CITY OF CODY  
PLANNING, ZONING AND ADJUSTMENT BOARD  
TUESDAY, JULY 24, 2012  
CITY HALL COUNCIL CHAMBERS @ 12:00 NOON

**CITY OF CODY  
PLANNING, ZONING AND ADJUSTMENT BOARD  
STAFF REPORT**

<b>MEETING DATE:</b>	JULY 24, 2012	<b>TYPE OF ACTION NEEDED</b>	
<b>AGENDA ITEM:</b>		P&Z BOARD APPROVAL:	X
<b>SUBJECT:</b>	SPECIAL EXEMPTION PUBLIC HEARING: REDUCE FRONT SETBACK REQUIREMENT FOR 614 6 <sup>TH</sup> STREET SUP 2012-07	RECOMMENDATION TO COUNCIL:	
<b>PREPARED BY:</b>	TODD STOWELL, CITY PLANNER	DISCUSSION ONLY:

Darin Samuels has submitted a Special Exemption application, requesting a six-foot reduction in the front setback requirement in order to construct a 26-foot wide by 30-foot deep garage on his home at 614 6<sup>th</sup> Street.

**SITE PLAN**  
 TODD JAY RENO COLLISION CENTER  
 2221 LT. CHILDERS ST.  
 WITHIN PORTIONS OF LOTS 6 AND 7  
 OF THE FRANK SUBDIVISION  
 EAST 1/2 NW 1/4, LOT 61, T52N, R101W, 6TH P.M.  
 WITHIN THE CITY OF CODY, PARK COUNTY, WY.

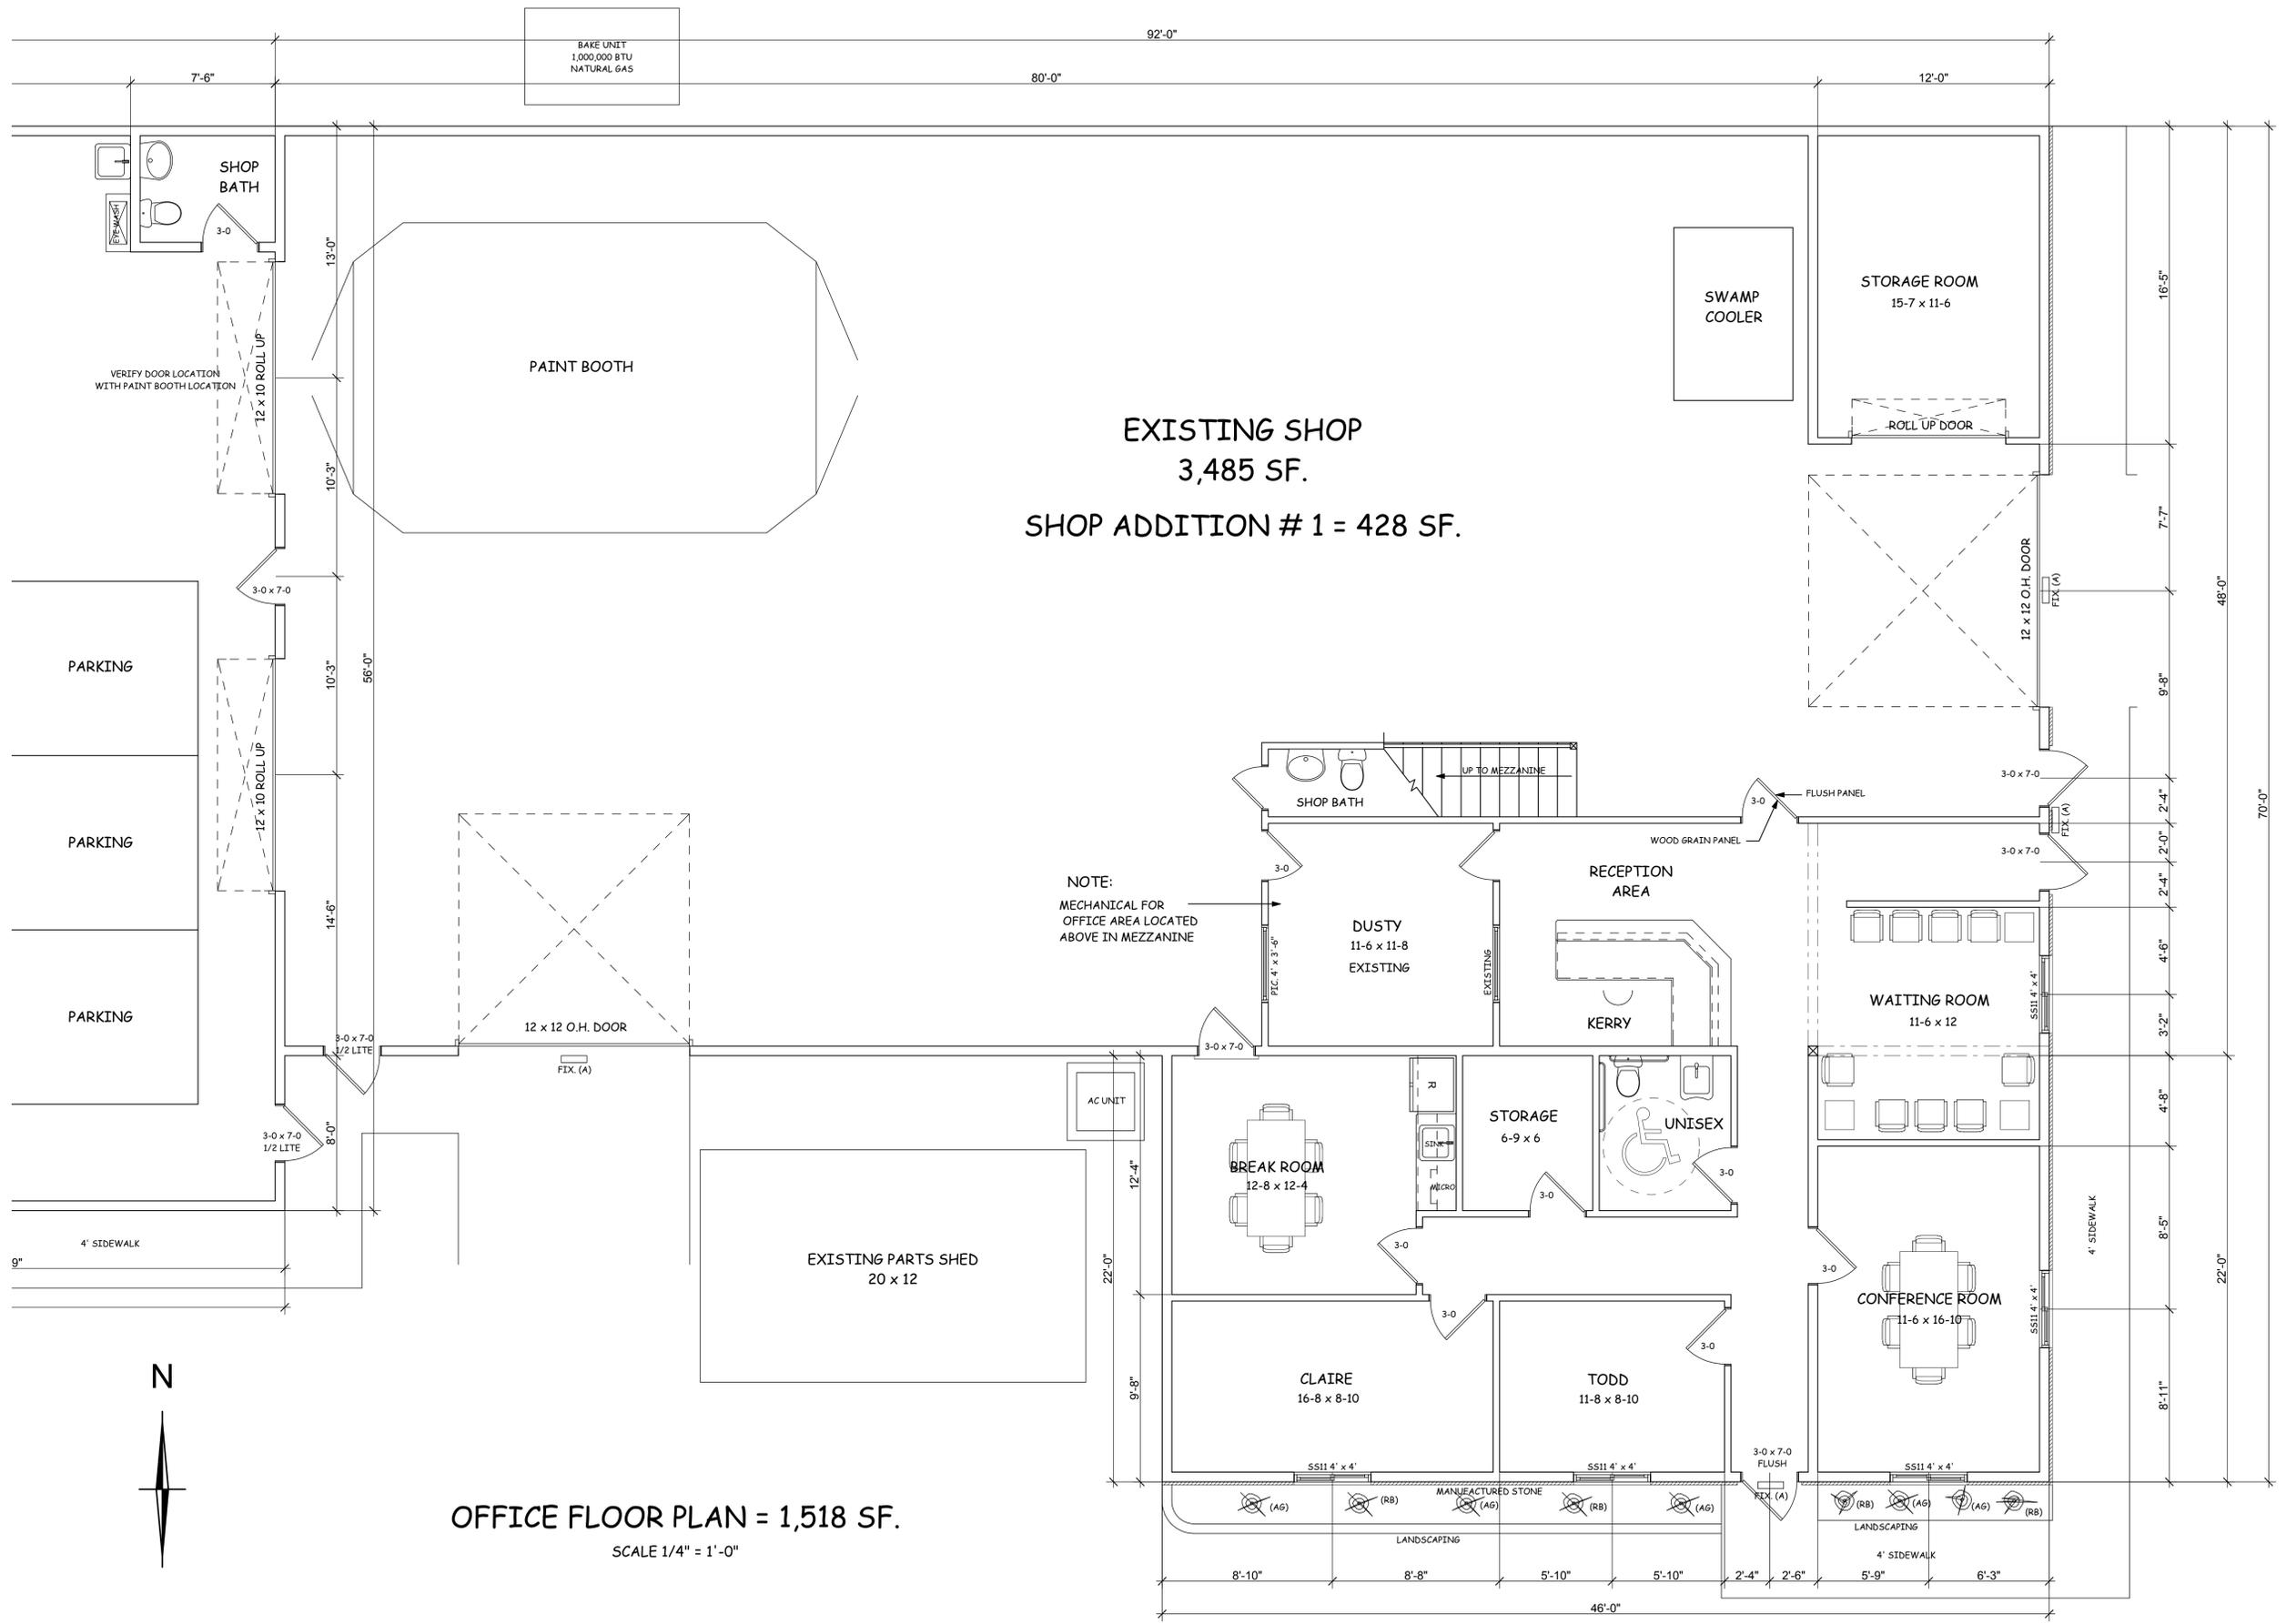
The amount of additional impervious surface is significant. An engineered storm water plan has been prepared to address the additional runoff according to the City's storm water policy manual. A trench drain south of the proposed shop addition and a drywell/infiltration trench west of the proposed shop addition are sized to accommodate the required amount of runoff. Because the area west of the shop addition also serves as an access easement to the lot to the north, the drywell pipe and case cover are to be traffic rated.

Additionally the applicant is finalizing an agreement to lease an area of Forward Cody's property, across Frank Court, for parking. The area will accommodate approximately twelve spaces (site plan attached), for a total of 32 spaces on both properties. This review includes that parking area as well. The primary concern is that there be adequate surfacing for weed control and that the parking area not be used for long-term vehicle storage. If the area is used for parking vehicles that are to be actively worked on and returned to the customer, then it is okay as proposed. If any longer term parking or storage is to occur, this parking compound would be required to be enclosed with a view-obscuring fence according to the current nuisance ordinance requirements.

6. That the business obtain and maintain the proposed parking agreement for the Forward Cody property unless and until it is demonstrated that the parking is no longer needed, as determined by the Planning and Zoning Board.
7. That the project must otherwise comply with the submitted site plan and applicable building, fire, and electrical codes. A building permit application is required.
